Location Map, Pablo Creek (DU-9)  
 Dredged Material Management Area  
 St. Johns County, Florida

Site Plan, Pablo Creek (DU-9)  
 Dredged Material Management Area  
 St. Johns County, Florida

RE: Public Notice - Florida Inland Navigation District -  
Long-Range Dredged Material Management Plan for  
Atlantic Intracoastal Waterway (Northeast Florida) -  
St. Johns County, Florida  
SAI: FL9508100837C

RE: U.S. Army Corps of Engineers Public Notice for Florida Inland Navigation District  
Long-Range Dredged Material Management Plan, St. Johns County  
SAI: FL9508100837C

**Wetlands Map, Pablo Creek (DU-9)**  
Dredged Material Management Area  
St. Johns County, Florida

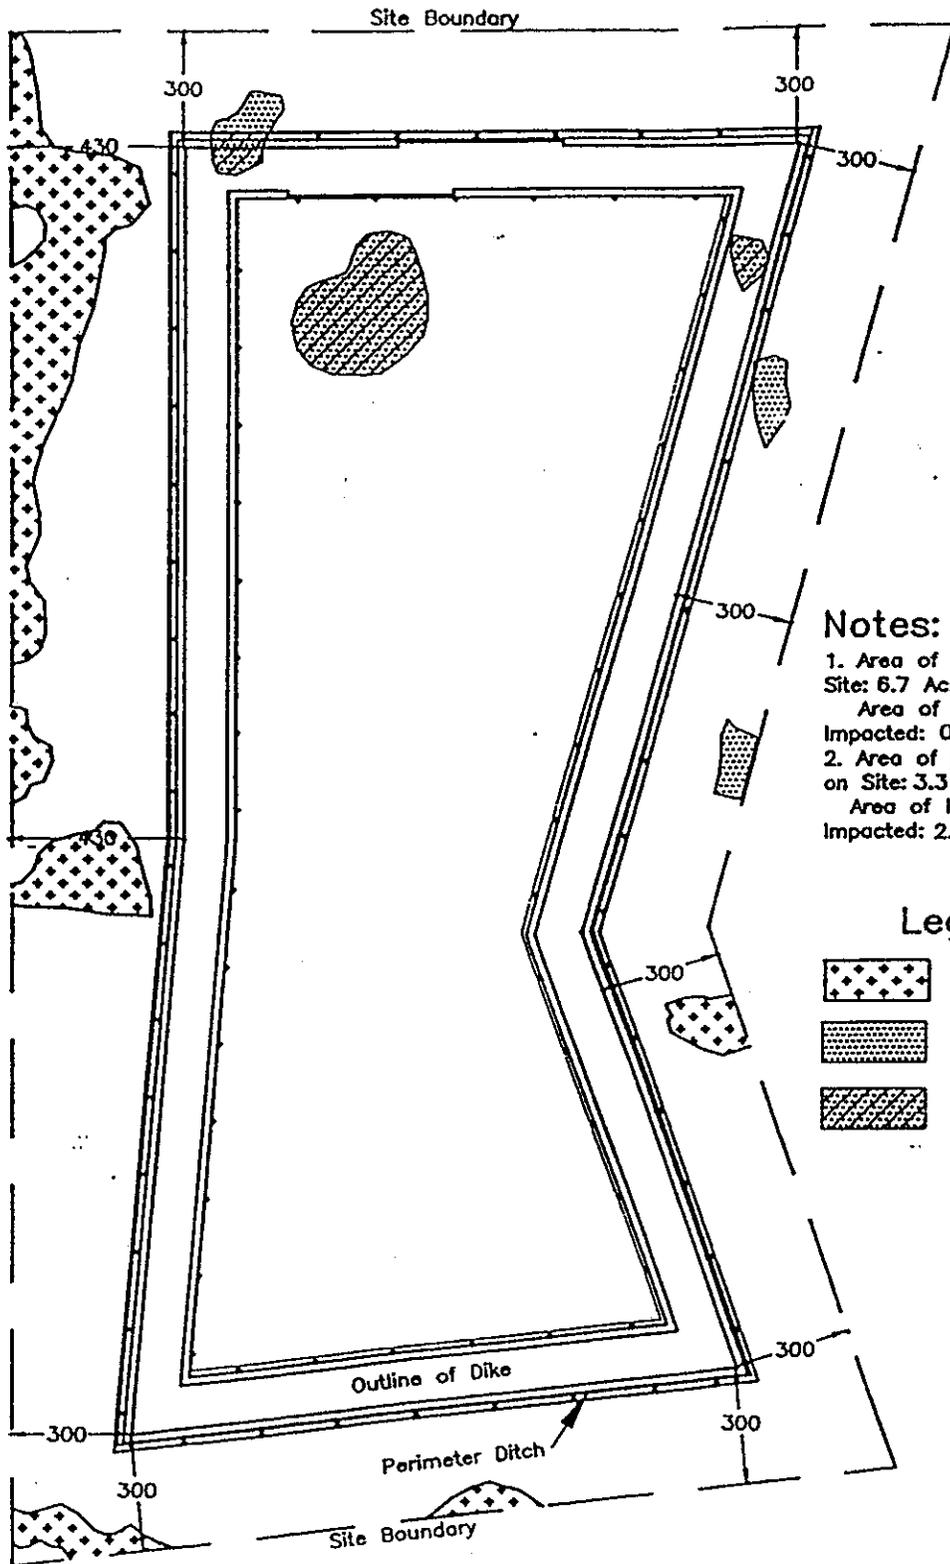
Pablo Creek site and the 6.5 acres of the Palm Valley site will involve filling of isolated wetlands. There are also contiguous wetlands adjacent to the proposed DMMA's. The current condition of the wetlands and uplands within and adjacent to these project sites should be thoroughly evaluated in the EA before finalizing the design and engineering of the DMMA's and applying for permits. Approval of the ERP is unlikely if the project is determined to cause adverse impacts to wetlands and uplands that provide habitat functions for endangered or threatened wetland-dependent species. In order to fully evaluate the project, we recommend that the EA include a preliminary mitigation plan.
